CLASS I SERVICE INSTRUCTIONS

No. 0717-159
ATA Code 73-20

SUBJECT: FLIGHT CONTROLS - ENGINE CONTROLS - INSPECTION OF MIXTURE CONTROL AND CARBURETOR HEAT CONTROL CABLES

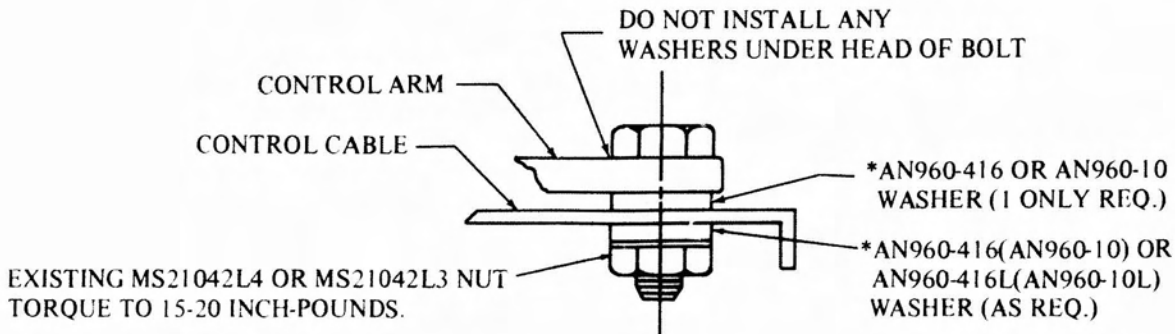
1. Remove the engine cowling.
2. Check for freedom of rotation of the bolt in the mixture control arm at the carburetor or fuel injector, as applicable. In the event the bolt does not rotate freely, refer to the illustration and adjust washers as necessary to lock the control in the bolt and obtain free rotation of the bolt in the arm to prevent breakage of the control wire.

***USE WASHERS APPROPRIATE TO THE SIZE OF THE EXISTING BOLT. THE BOLT MUST SWIVEL FREELY IN THE CONTROL ARM.**

Torque the nut to 15-20 inch-pounds.
